REVISED HONDA VALIDATION TEST REPORT

Revised Report – 1st Copy
November 06, 2000
Document Number ERL-0164
Thomas Sheridan

Product: P-SDI Inflator

To: Bill Martin / Kevin Fitzgerald
From: Tom Sheridan
Subject: Corrected Honda Test data

HONDA PSDI Group 9 (Vibration / Thermal Shock)
@ +85 deg.C (Hot) Simultaneously

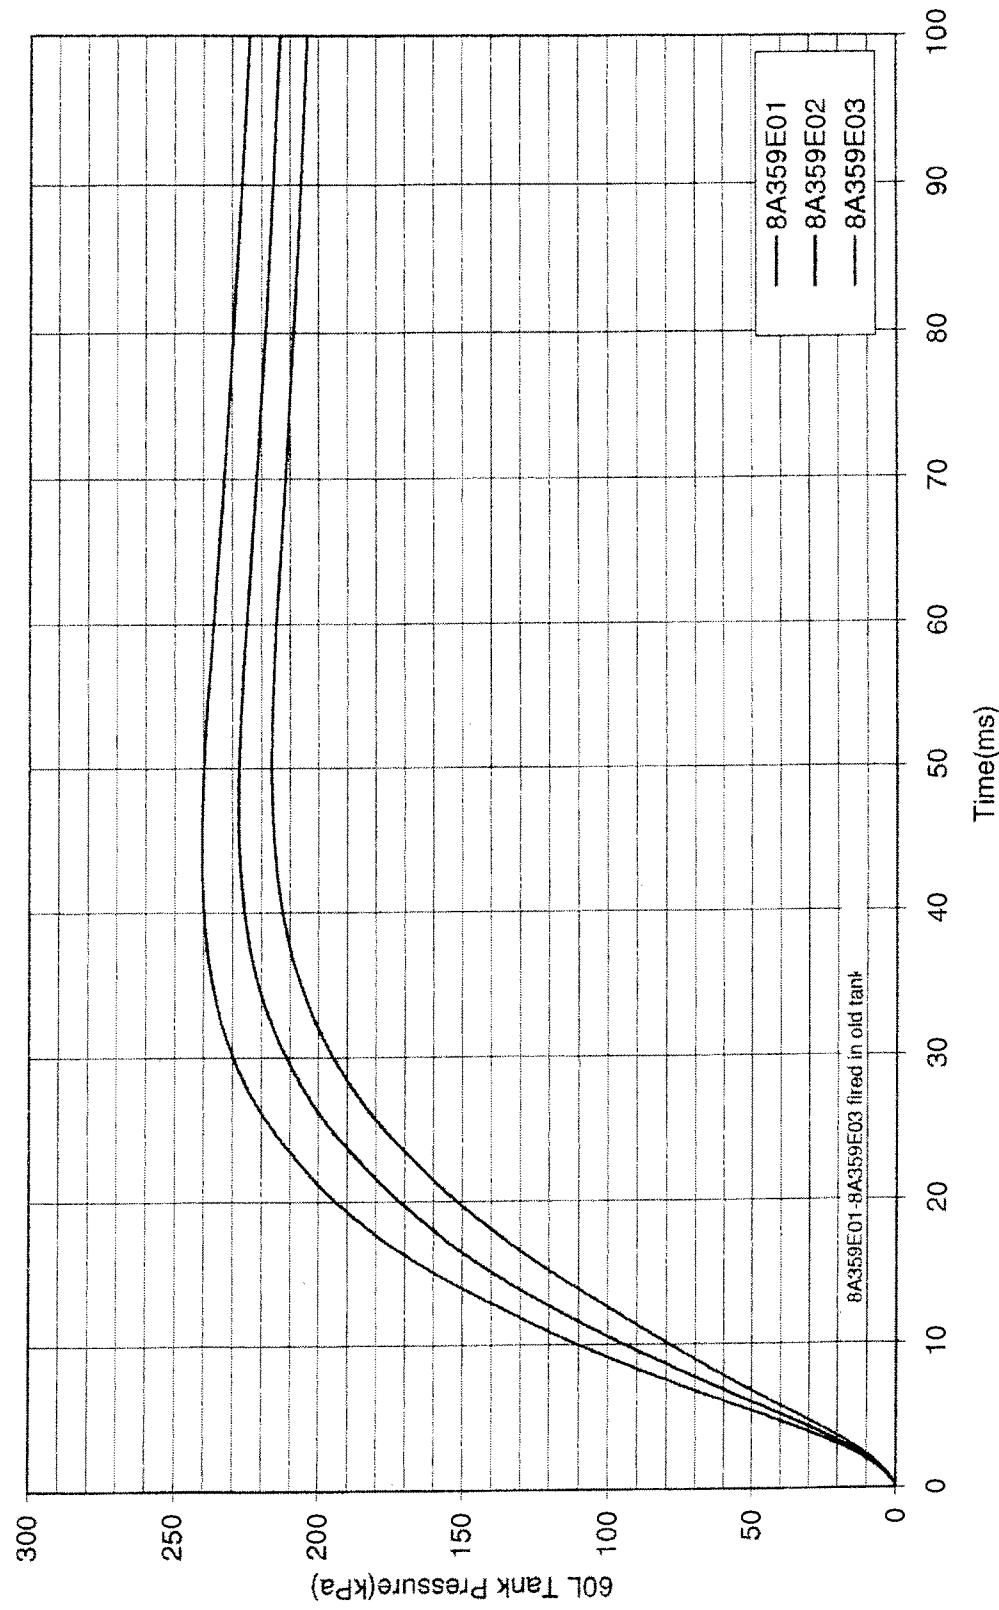
Incorrect data.
Data does not match EAR.
8A359E01-8A359E03 corrected
data on following page.

Corrected chart and data for
8A359 Group E.

HONDA PSDI Group 10 (Drop Test)
@ +22 deg.C (Amb) 20ms delay

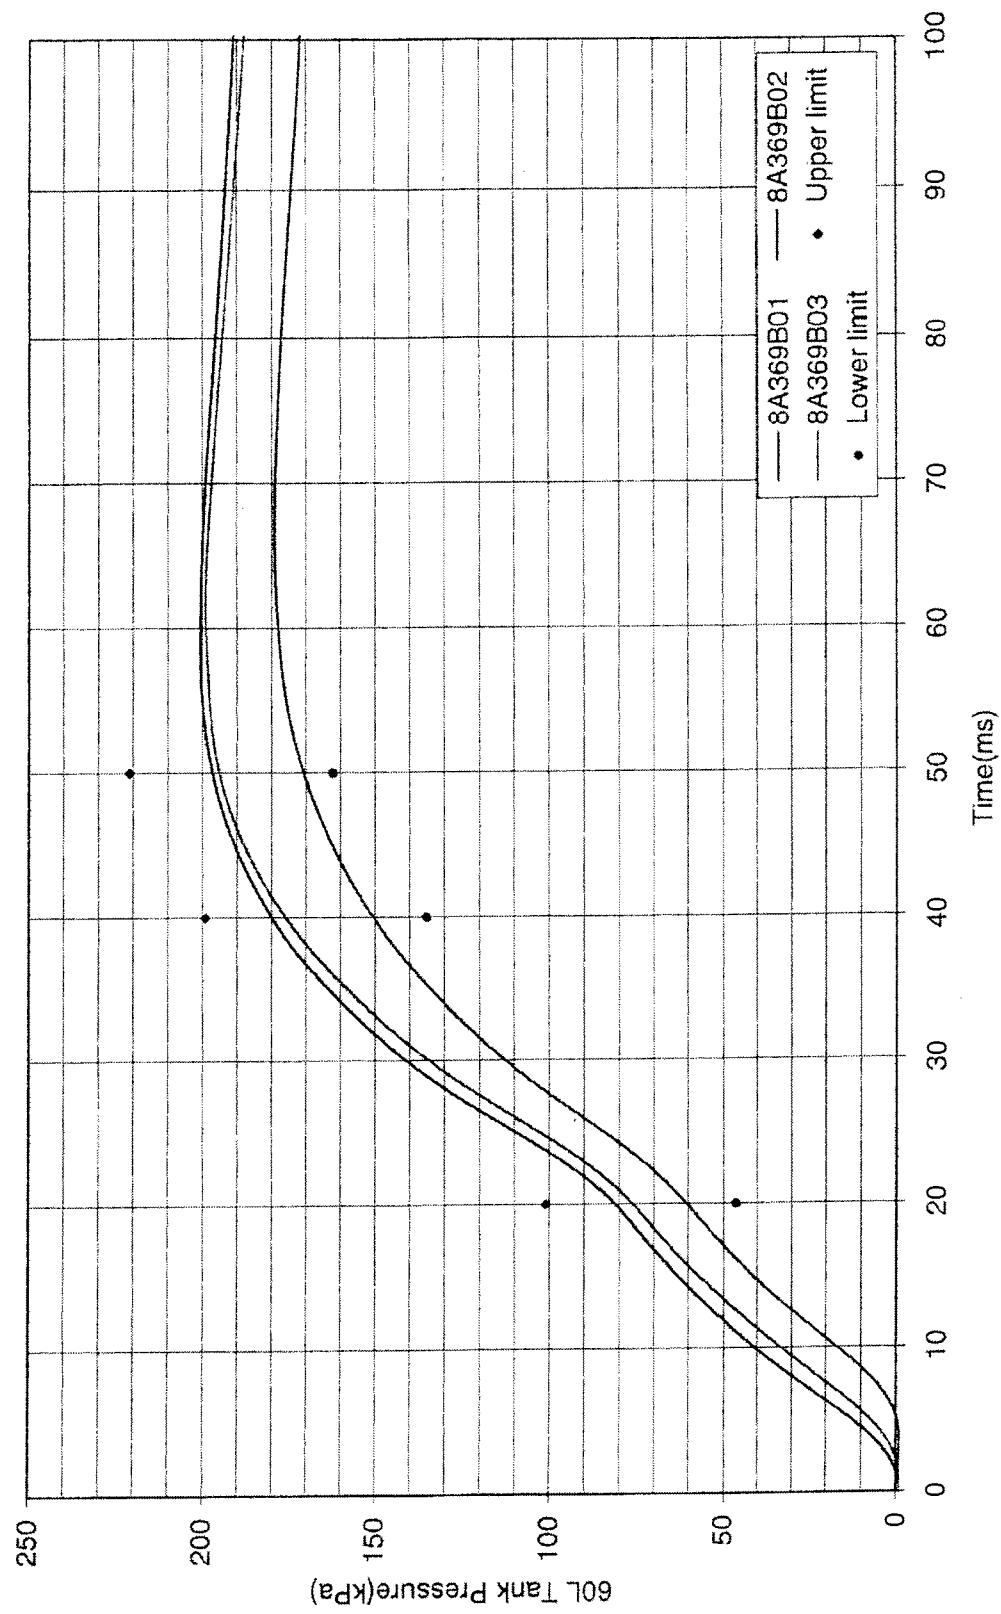
Incorrect data.
Data does not match EAR.
8A369B01-8A369B03 corrected
data on following page.

Corrected chart and data for
8A369 Group B.

HONDA PSDI Group 10 (Drop Test)
@ -35 deg.C (Cold) Simultaneously

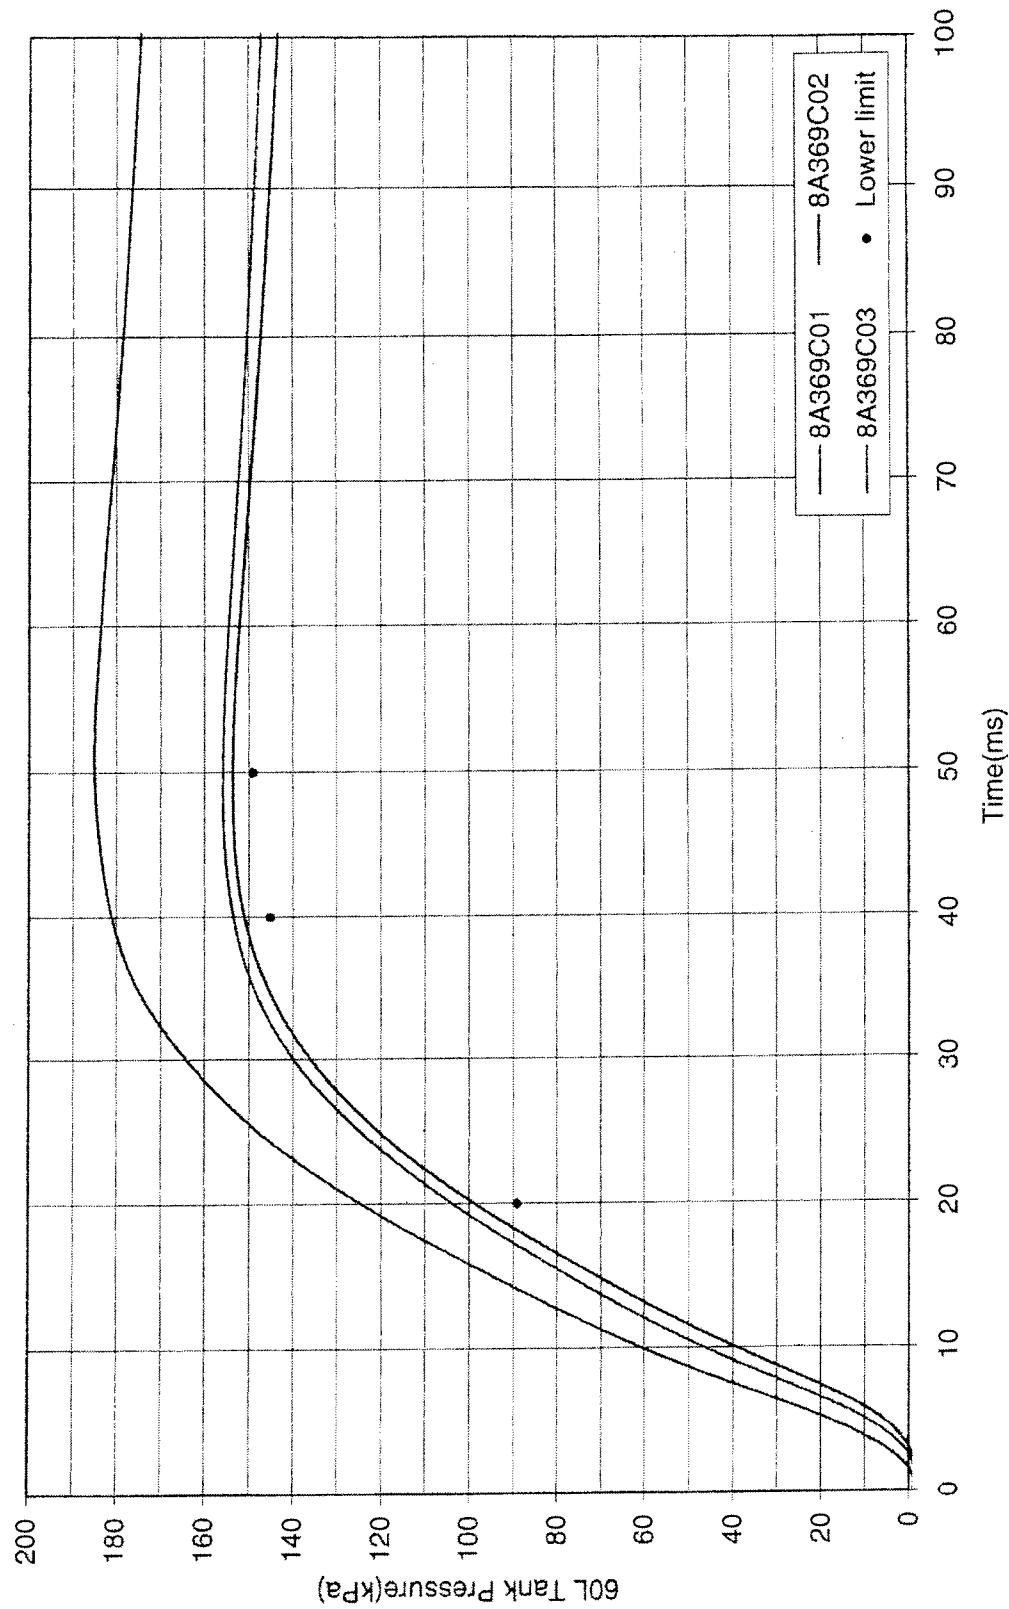
Incorrect data.
Data does not match EAR.
8A369C01-8A369C03 corrected
data on following page.

Corrected chart and data for
8A369 Group C.

HONDA PSDI Group 10 (Drop Test)
@ -35 deg.C (Cold) 20ms delay

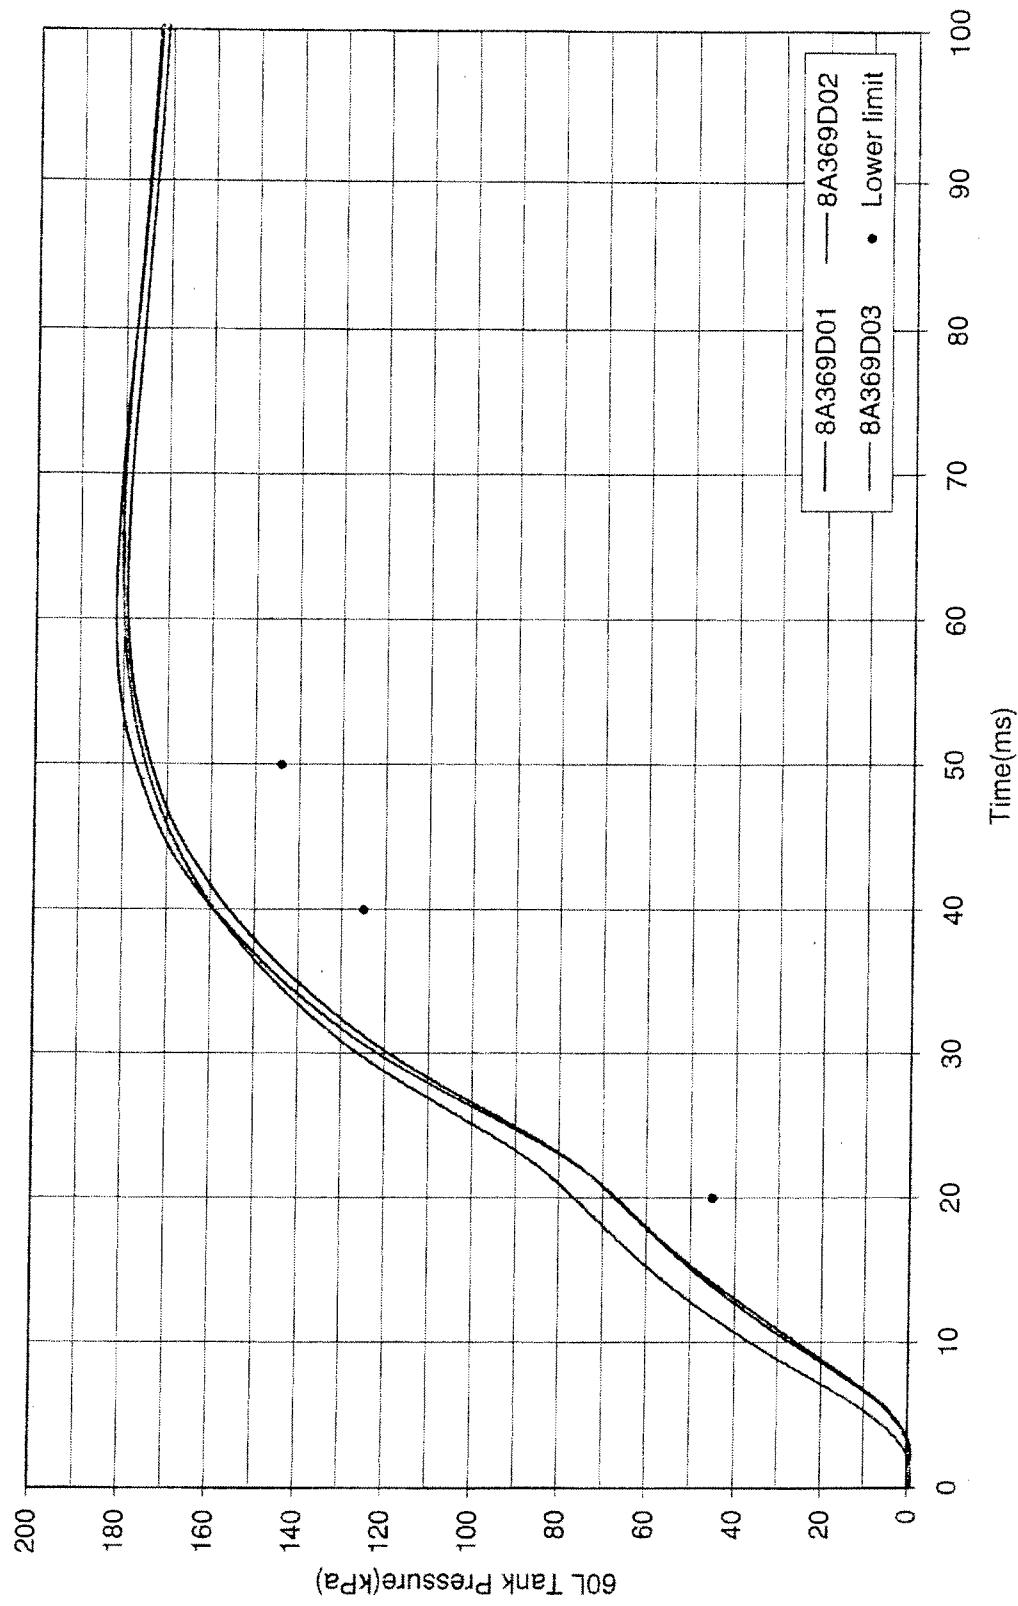
Incorrect data.
Data does not match EAR.
8A369D01-8A369D03 corrected
data on following page.

Corrected chart and data for
8A369 Group D.
